# Authorized Field Change

AFC 08904

**Subject:** VT 275 and MaxxForce 5 Case to Head Tube and Plug D-Ring Seal Deterioration

Model: Workhorse Chassis : WAZ, W6Z

**Figure 6 Crankcase-to-Head Tube Assemblies**

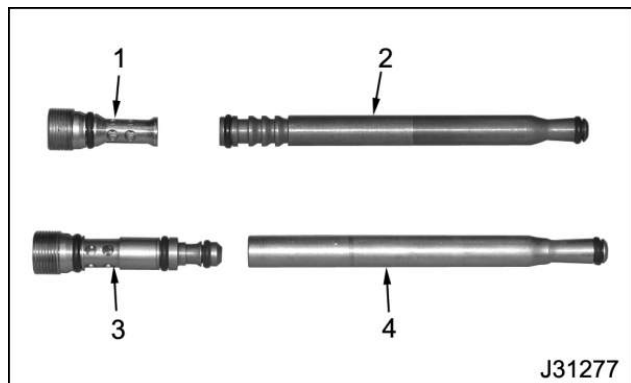
**NOTE** – The square socket short crankcase-to-head tube plug and crankcase-to-head tube assembly is not available for service (Figure 7, Items 1 and 2; service with Items 3 and 4).

**NOTE** – The lower crankcase-to-head tube (Item 4, Figure 6), used with the long crankcase-to-head tube plug, may remain in the crankcase.

25. Tighten M6 x 40 bolts to 13 Nm (115 lbf-in) torque in the above sequence (Figure 12).
26. Lubricate the D-rings on the case-to-head tube (Figure 6, Item 4) with clean engine oil and install into the branch tube.
27. Install right case-to-head tube plug (Figure 6, Item 3) and rail port plug.
28. Tighten case-to-head tube assembly to special torque 82 N-m (60 lbf-ft).
